## Product Change Notification

1. ECN #: 299762

- IDSD - INSULATION DISPLACEMENT TERMINAL CABLE

New modified body pic 1

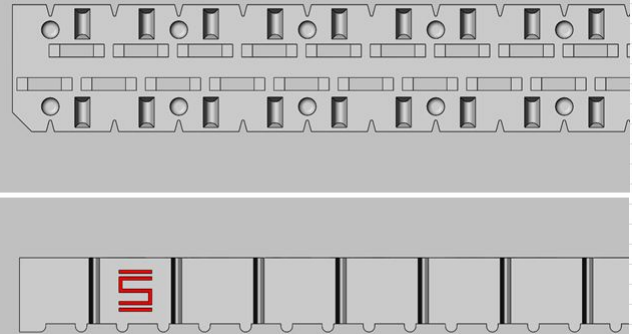
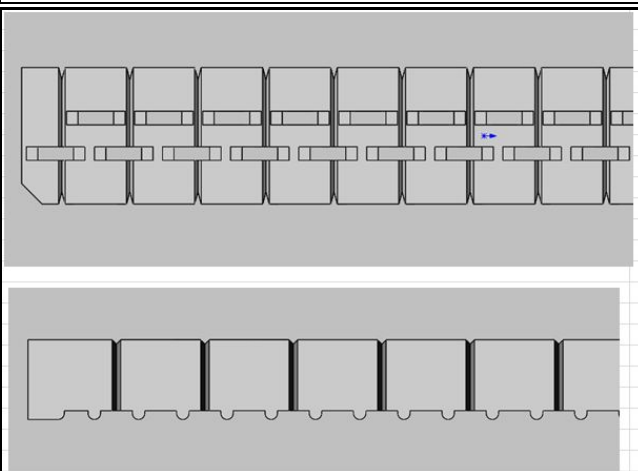
Add void corings on the top surface and change material from PBT VALOX DR-48 to PBT 4521.

Visual inspection; voids will be noticed on the top of body where prior revision had no voids; this is a rolling change and there is some opportunity for mixed inventory on a limited basis.
